DEPARTMENT OF ENERGY

[Docket No. EERE-2014-BT-TP-0008]

Energy Conservation Program for Certain Commercial and Industrial Equipment: Test Procedure for Commercial Water Heating Equipment

ACTION: Final rule.

Figure III.1. Test set-up for gas-fired and oil-fired storage water heaters and storage-type instantaneous water heaters equipped with vertical (top) connections

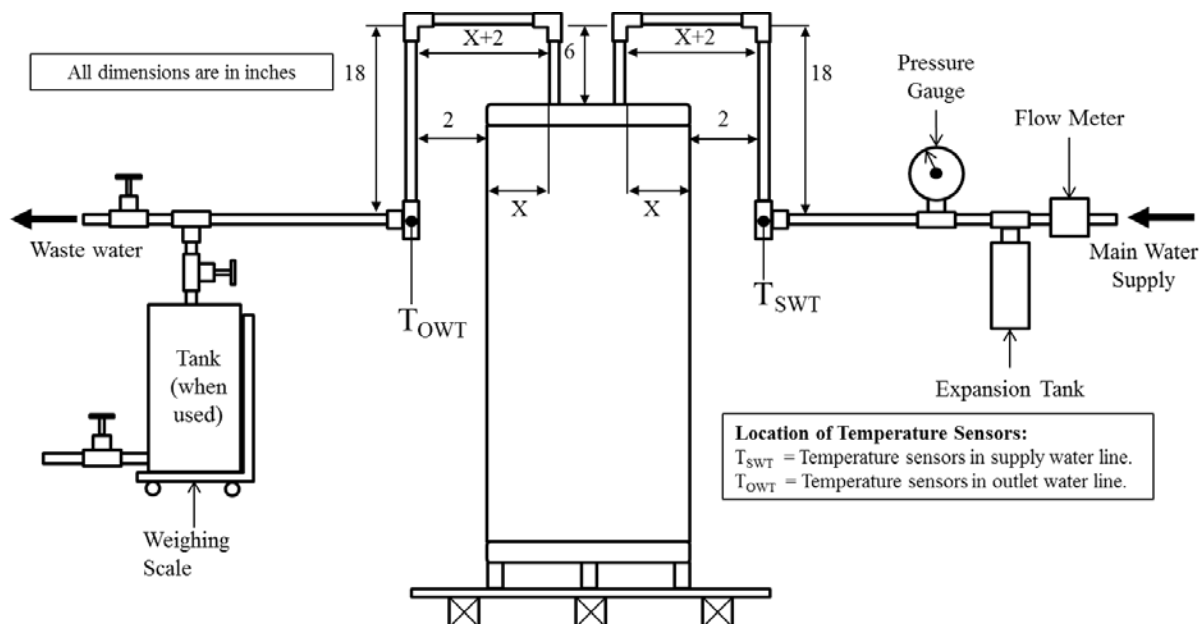
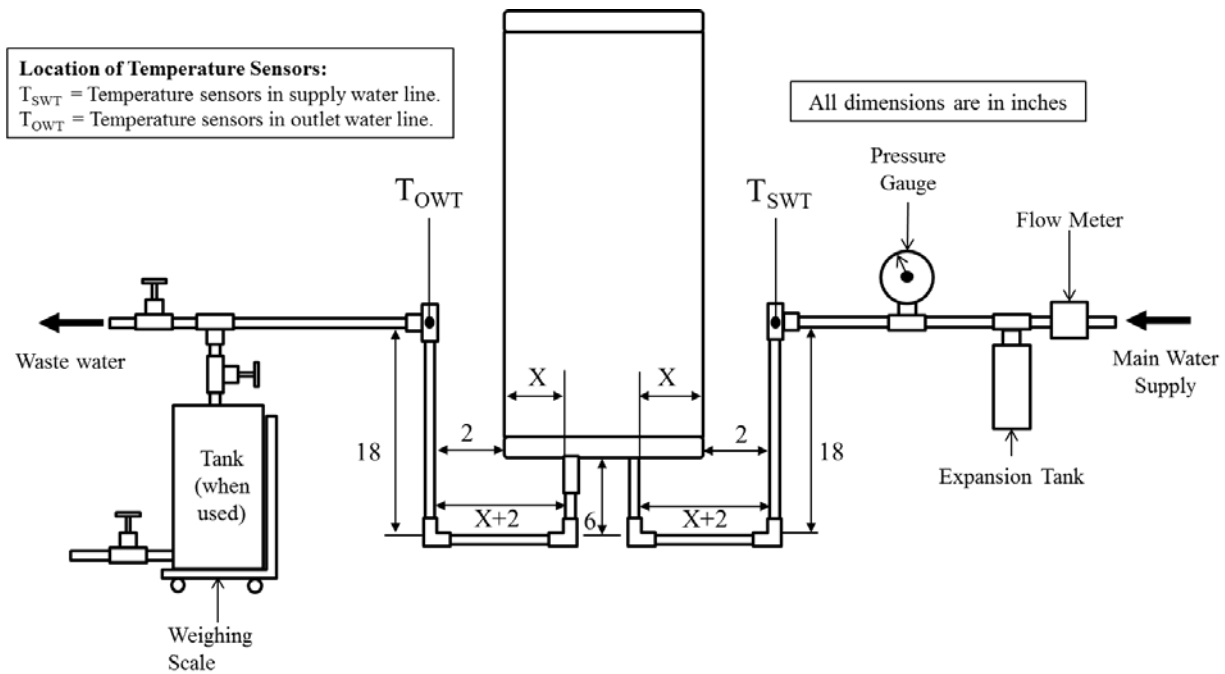
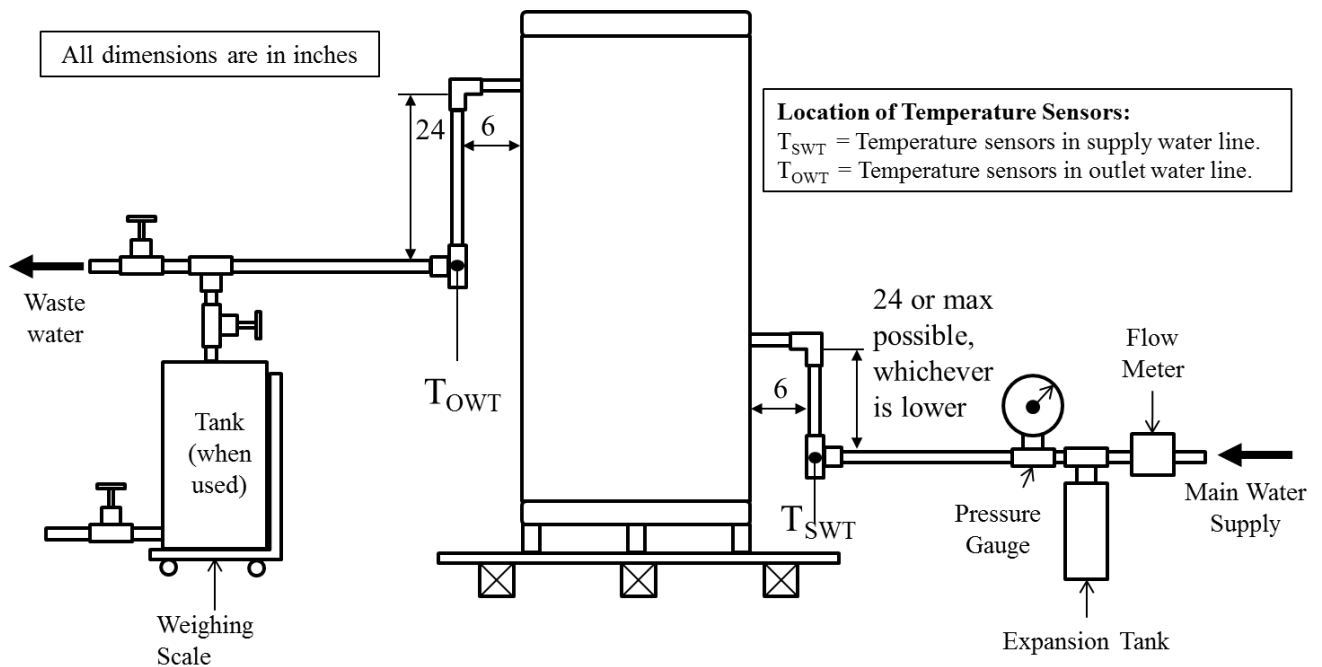
Based on the foregoing, DOE is adopting the test set-ups shown in Figures III.1, III.2, and III.3 for gas-fired and oil-fired storage water heaters and gas-fired and oil-fired storage-type instantaneous water heaters. In addition, DOE uses very similar test set-ups for other types of CWH equipment. Specifically, as discussed in section III.I.5, the set-up for instantaneous water heaters and hot water supply boilers is the same as shown in Figures III.1, III.2, and III.3, except

that an outlet water valve and heat exchanger outlet temperature sensor are required. DOE has concluded that these changes are consistent with the approach in ANSI Z21.10.3-2015, but will provide additional specificity and improve test repeatability. The test set-ups for electric storage water heaters and storage-type instantaneous water heaters are similar to the test set-ups shown in Figures III.1, III.2, and III.3, with the only difference being that the outlet water temperature sensor is not present. An outlet water temperature sensor is not needed for testing electric storage water heaters and storage-type instantaneous water heaters, because the outlet water temperature is not measured during the conduct of the test.

Figure III.4. Test Set-up for Instantaneous Water Heaters and Hot Water Supply Boilers (Other Than Storage-Type Instantaneous Water Heaters) When Tested With a Recirculating Loop

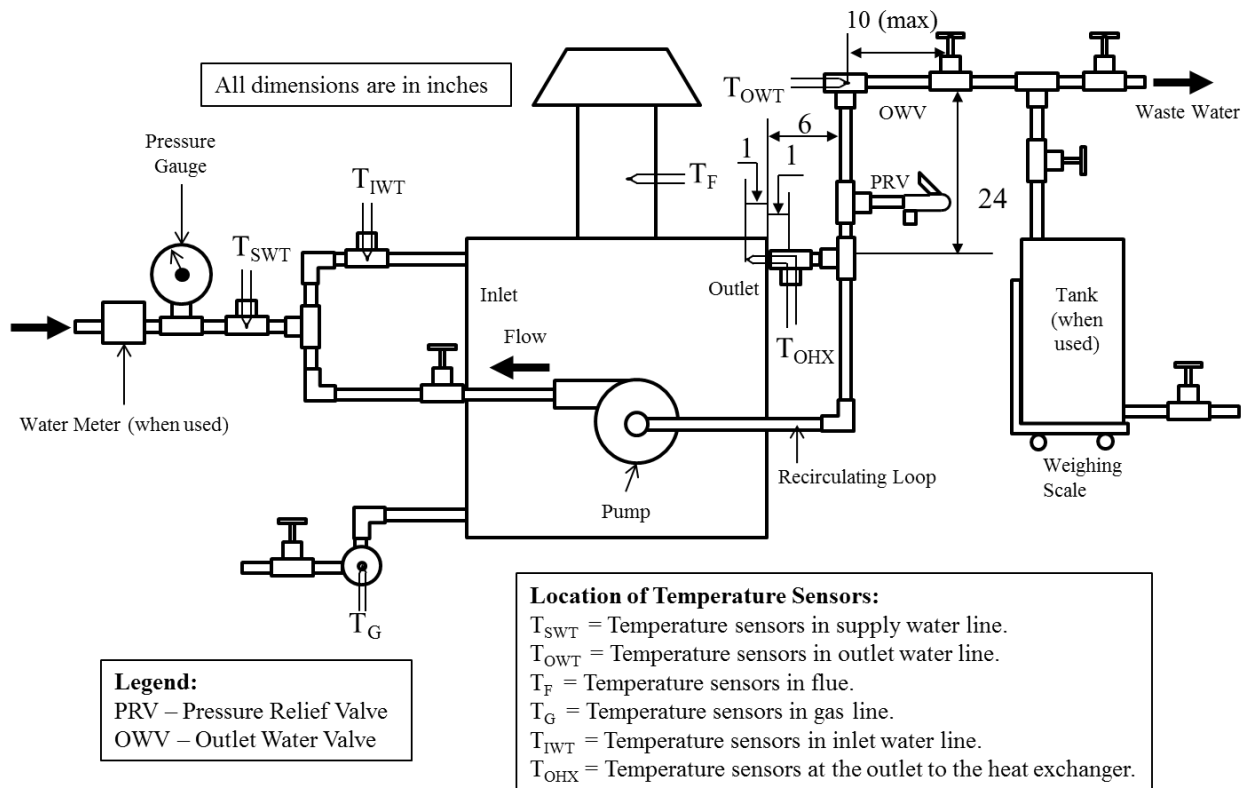
In addition to comments related to the test set-up, DOE also received comments about measuring the gas line temperature as indicated by temperature probe T₄ in Figure III.4 of the May 2016 NOPR for instantaneous water heaters and hot water supply boilers. DOE received comments from Raypak and Rheem stating that the T₄ is generally part of the gas meter or otherwise must be measured at the gas meter and not elsewhere in the gas line. (Raypak, No. 28 at p. 3; Rheem, No. 34 at p. 17) Raypak commented that most of the thermocouples used to measure the temperature in the gas line are actually mounted in the gas meter and recommended indicating the location of the temperature sensor in the gas meter itself, located in the gas connection in Figure III.4 in the May 2016 NOPR. (Public Meeting Transcript, No. 20 at p. 88)

DOE agrees with the comments on the gas temperature measurement and has modified the test set-up to have the gas temperature measured at the gas meter. DOE concludes that this clarification is consistent with ANSI Z21.10.3-2015.

After considering this and all of the other comments related to the test set-up for instantaneous water heaters and hot water supply boilers, DOE has decided to allow the use of the same piping configuration adopted for storage water heaters to be used for testing instantaneous water heaters and hot water supply boilers that do not require a recirculating loop. As a result, the piping arrangements in Figure III.1, Figure III.2, and Figure III.3 adopted in this final rule (see section III.C) are also applicable to instantaneous water heaters and hot water supply boilers that do not require a recirculating loop for testing. Although the same piping arrangements are being adopted for instantaneous water heaters and hot water supply boilers, there are some variations in the setup needed to accommodate testing of instantaneous water heaters and hot water supply boilers. Specifically, instantaneous water heaters and hot water

supply boilers require the addition of an outlet water valve and the inclusion of an additional temperature sensor to measure the heat exchanger outlet water temperature. Figure III.1, Figure III.2, and Figure III.3 show the test setup for gas-fired and oil-fired storage water heaters and storage-type instantaneous water heaters, and are generally applicable to electric storage and storage-type instantaneous water heaters and to instantaneous water heaters and hot water supply boilers (that are not tested with a recirculating loop), with the exceptions that an outlet water valve and heat exchanger outlet temperature sensor are present. In this final rule, for clarity, DOE is adopting separate figures within each appendix, with the slight variations to outlet valve and temperature sensors discussed herein.

In addition, for instantaneous water heaters and hot water supply boilers, DOE is adopting Figure III.4, which must be used for the installation of the recirculating loop to conduct the thermal efficiency and standby loss test (as applicable).
